FINAL DRAINAGE REPORT
for
MAYBERRY, COLORADO SPRINGS – FILING NO. 3

May 17, 2022

JPS Project No. 030502
EPC Project No. SF-22-___

**FILING NO. 2-4
DEVELOPED DRAINAGE PLAN**

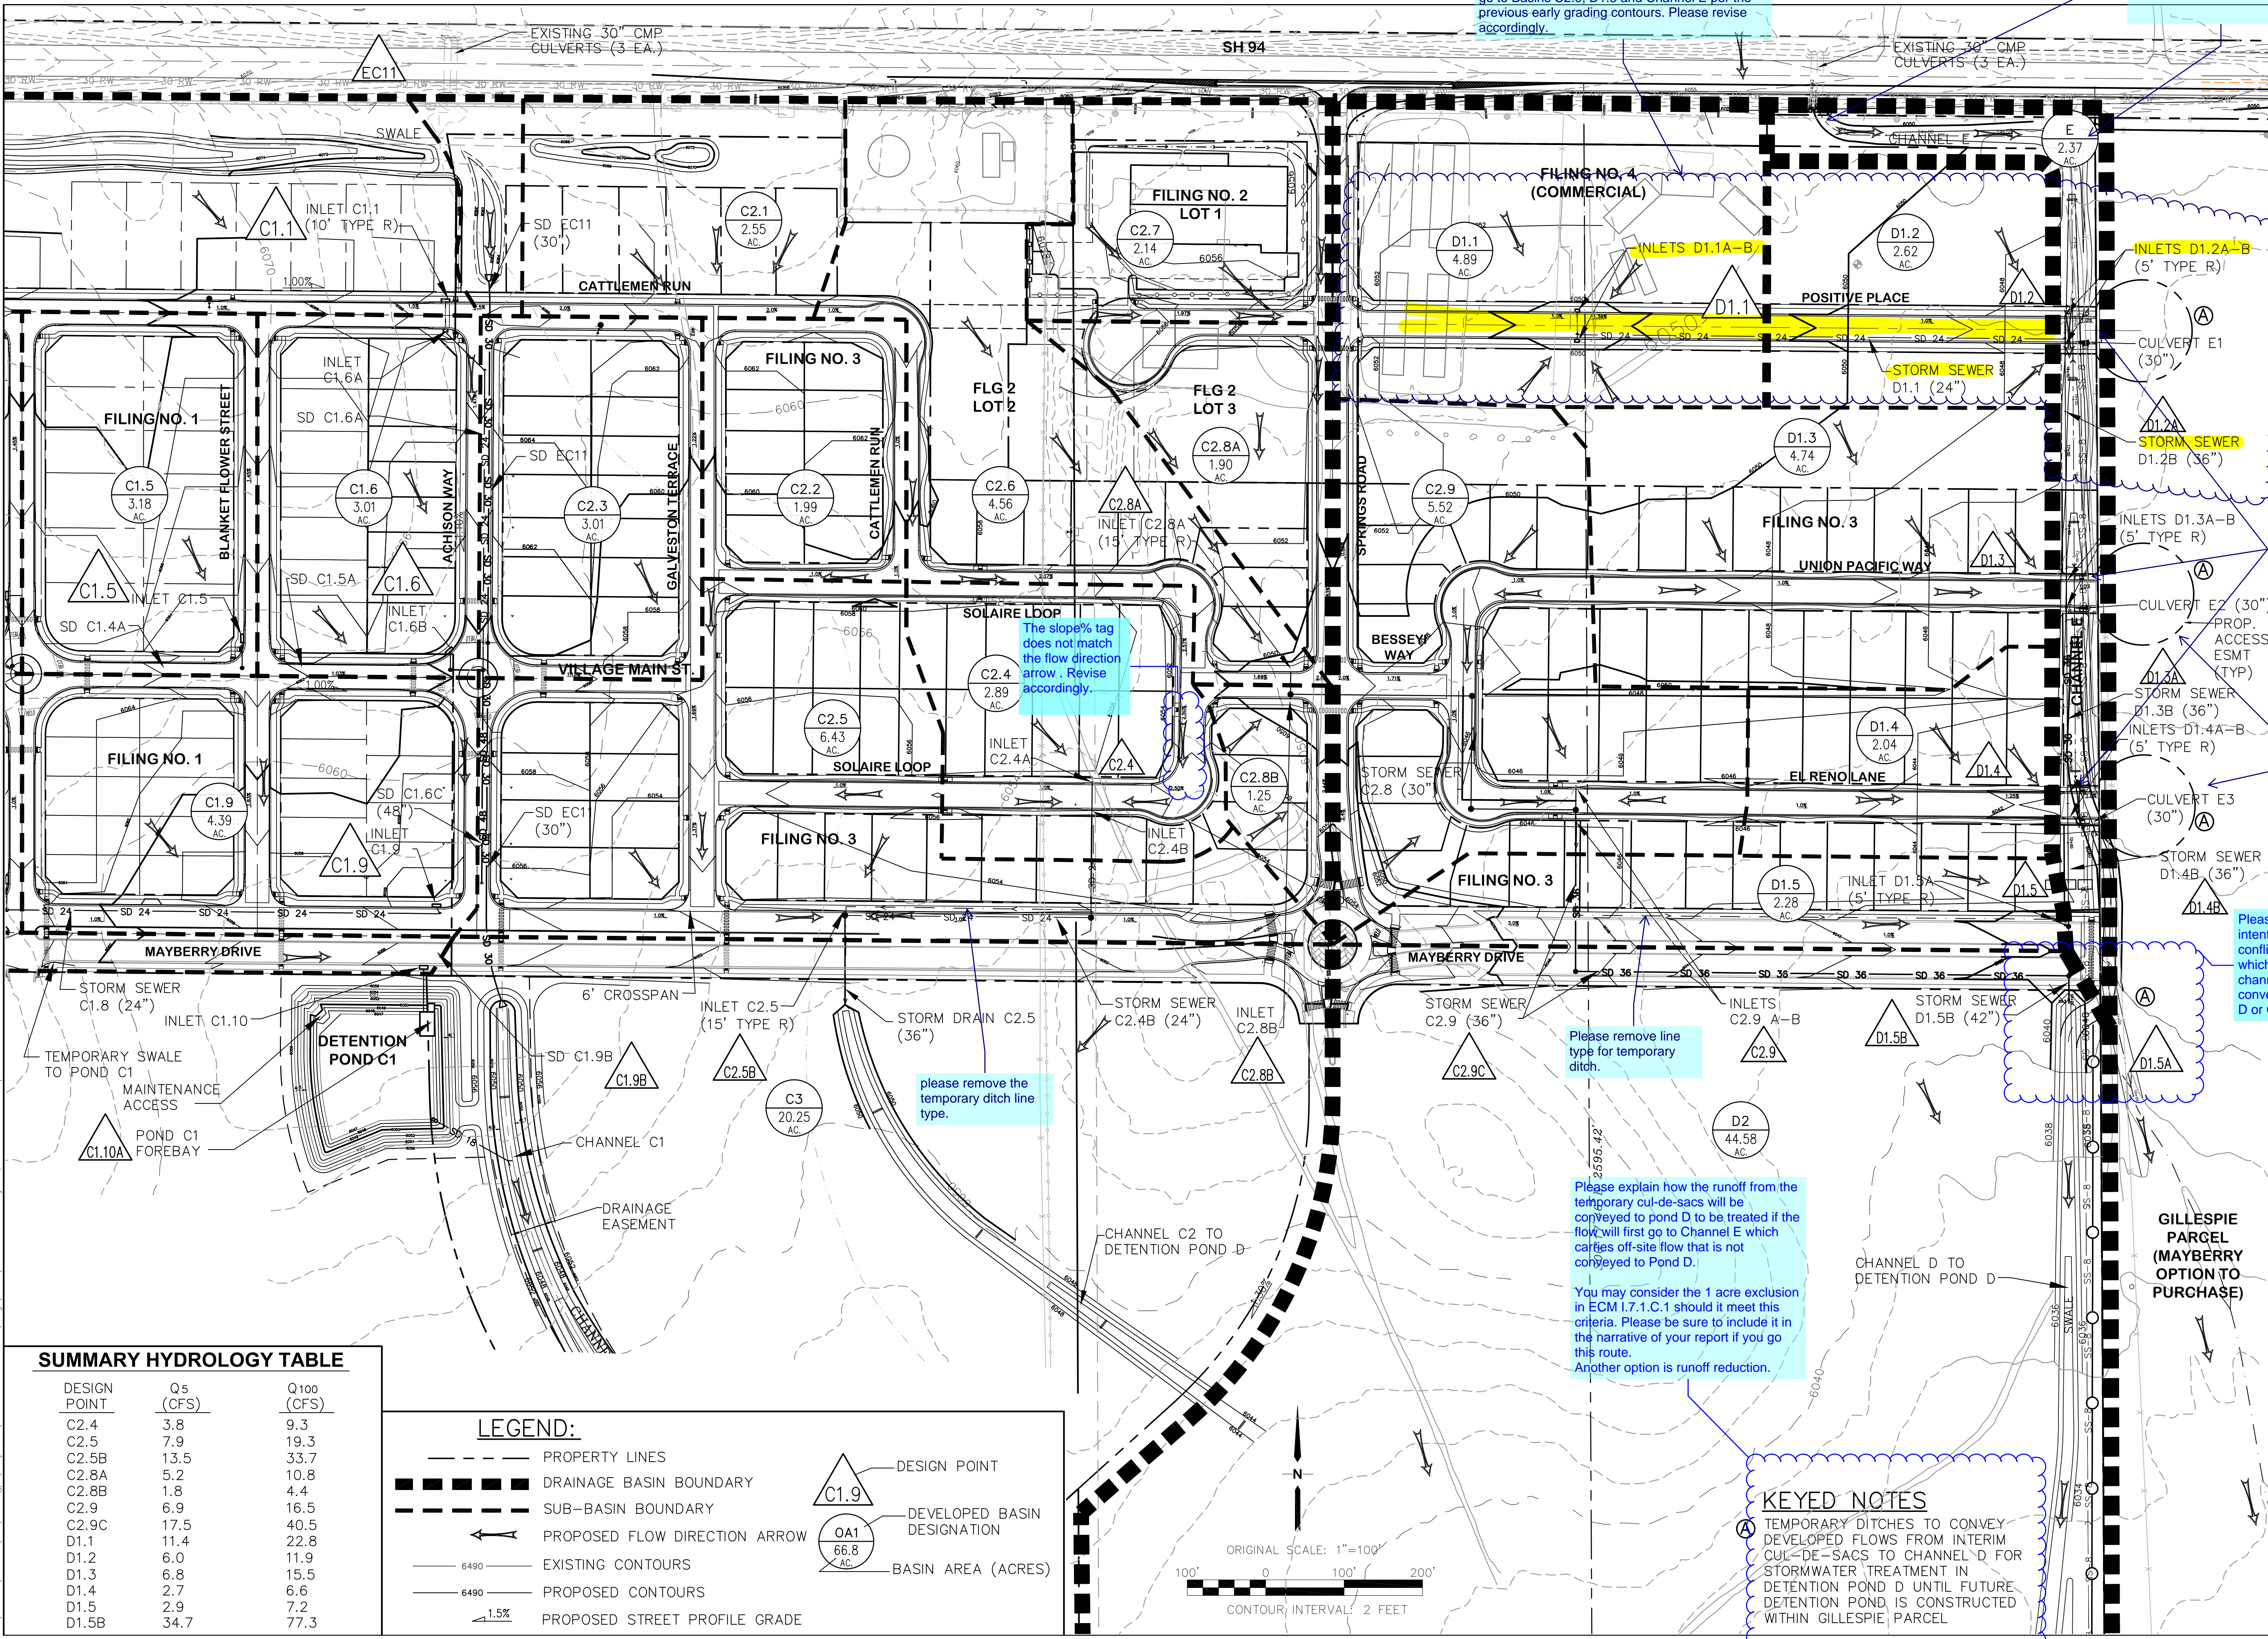
The street grading, inlets storm sewers should not be shown as they do not reflect actual conditions for Filing 3. Flow from these basins will go to Basins C2.9, D1.3 and Channel E per the previous early grading contours. Please revise accordingly.

Please provide hydraulic analysis at the bend. See ECM 3.3.3.E and DCM 10.5.6

The slope% tag does not match the flow direction arrow. Revise accordingly.

please remove the temporary ditch line type.

Please remove line type for temporary ditch.

Please show the proposed grading finished conditions and drainage of the temp. cul-de-sacs.

Please clarify your intent as there are conflicting contours, which way will the channel flow be conveyed to, Channel D or Gillespie parcel?
